**Bartlesville City Hall, Bartlesville, Oklahoma
ADDENDUM 2**

**The following are changes/clarifications/substitution approvals to the contract documents.
This addendum will now be part of the contract documents.**

BARTLESVILLE CITY HALL

A102

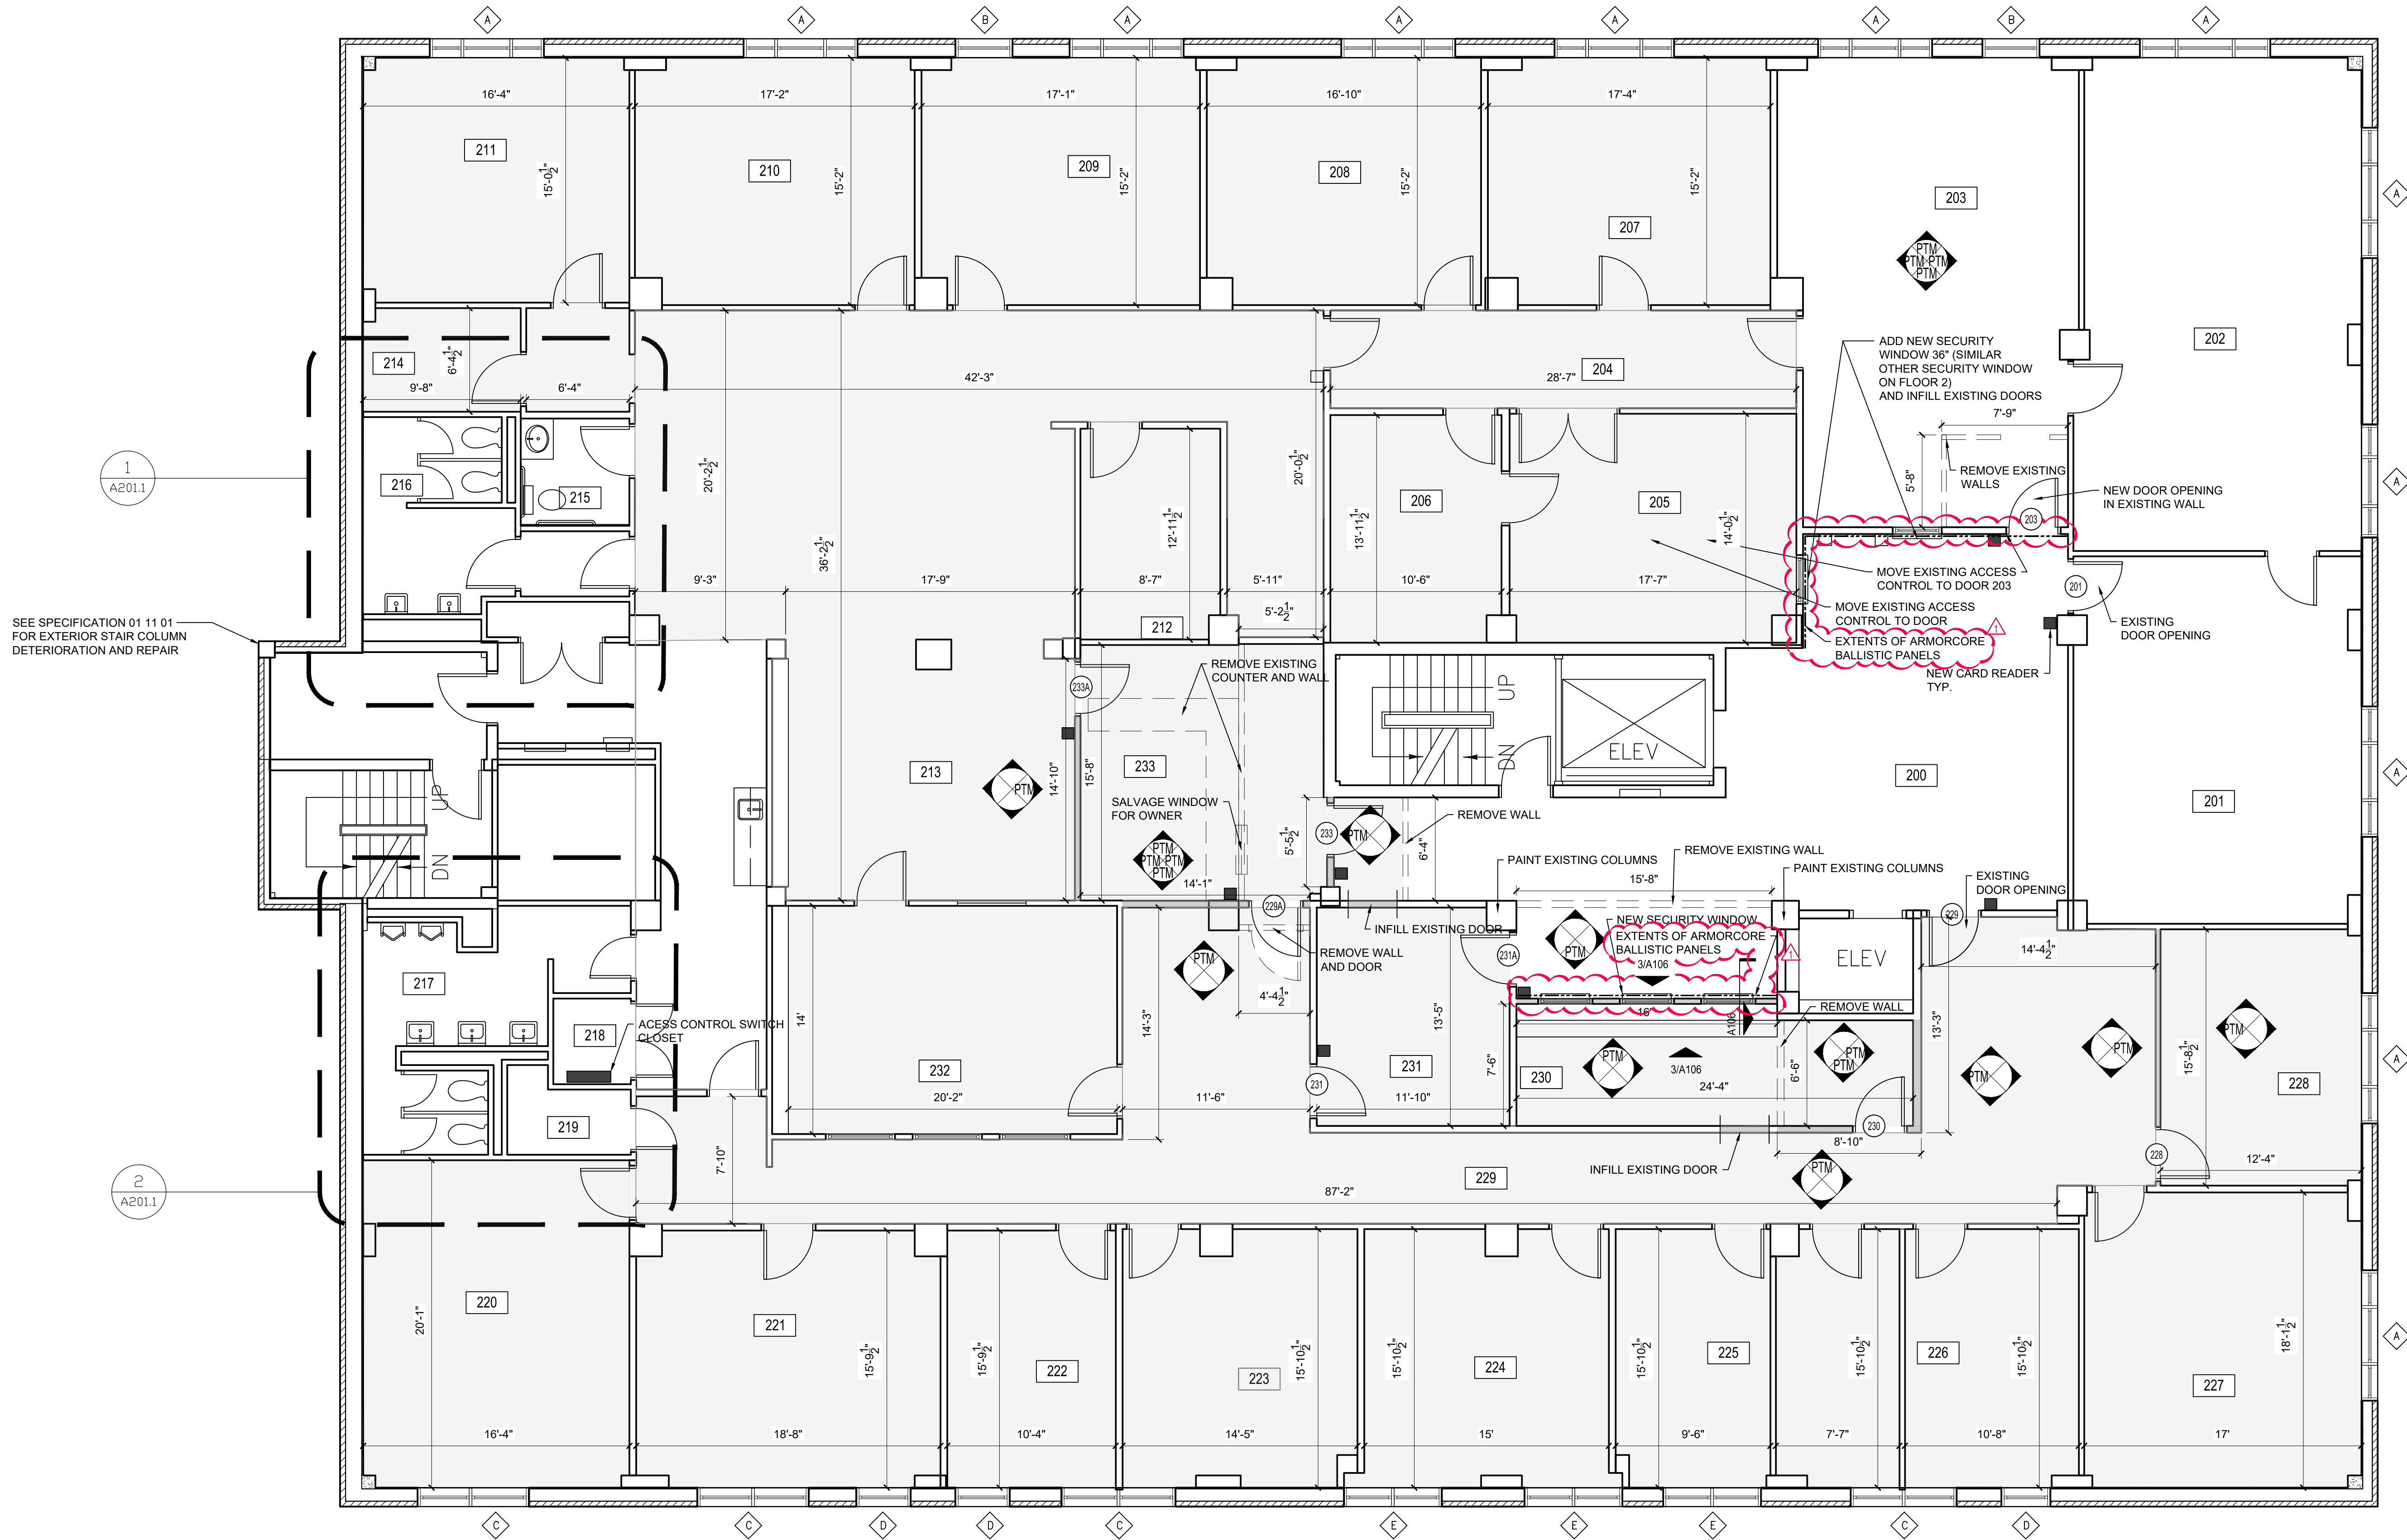
1. Extents of Armorcore ballistic panels has been clarified. See attached drawing sheets.
2. Knockdown frames are allowed in lieu of welded frames.
3. Temporary openings per floor are allowed.
